AMENDMENT NO. 5 JANUARY 2014
TO
IS 9206 : 1979 DIMENSION OF CAPS FOR TUNGSTEN
FILAMENT GENERAL SERVICE ELECTRIC LAMPS

Table 1 Dimensions of Normal Bayonet Cap B-22/25 × 26 and B-22/23 × 26

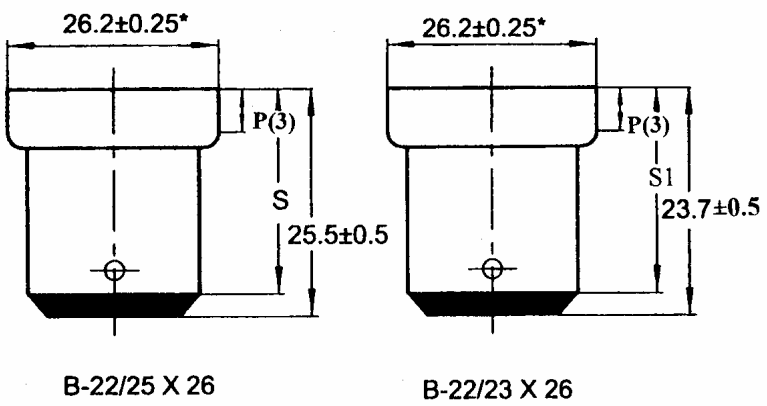
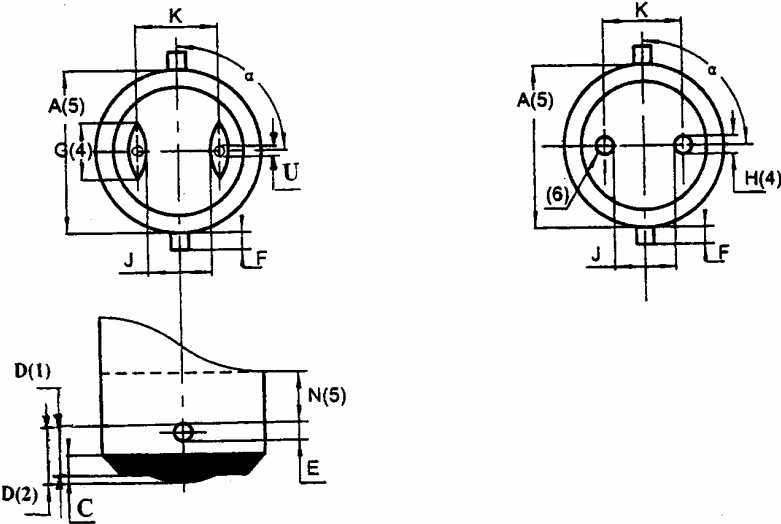
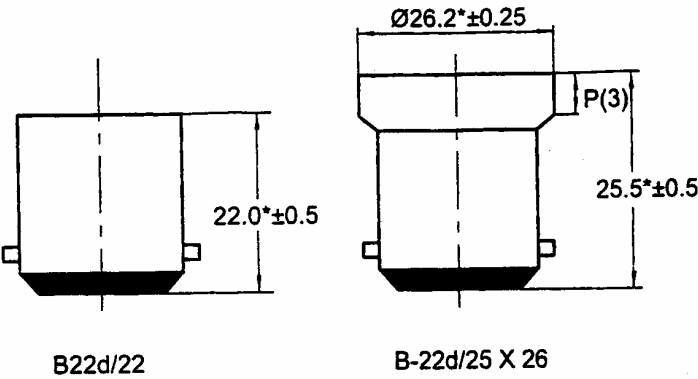
(Page 4, Table 1) — Substitute the following for the existing table:

SI No. (1)	Dimension (2)	Minimum (3)	Maximum (4)
i)	<i>A</i> (5)	21.75	22.15
ii)	<i>C</i>	1.9	2.5
iii)	<i>D</i> (1) ¹⁾	6.0	6.8
iv)	<i>D</i> 1(2)	—	8.0
v)	<i>E</i>	1.8	2.2
vi)	<i>F</i>	2.3	2.7
vii)	<i>G</i> (4)	10.0	—
viii)	<i>H</i> (4)	4.8	—
ix)	<i>J</i>	4.0	—
x)	<i>K</i> ¹⁾	10.3	10.5
xi)	<i>N</i> (5)	6.7	
xii)	<i>P</i> (3) ¹⁾	7.5	8.5
xiii)	<i>S</i> (B-22/25x26)	23.0	23.5
xiv)	<i>S</i> 1 (B-22/23x26)	21.3	21.7
xv)	<i>U</i>	—	1.75
xvi)	<i>A</i> ¹⁾	88°	92°
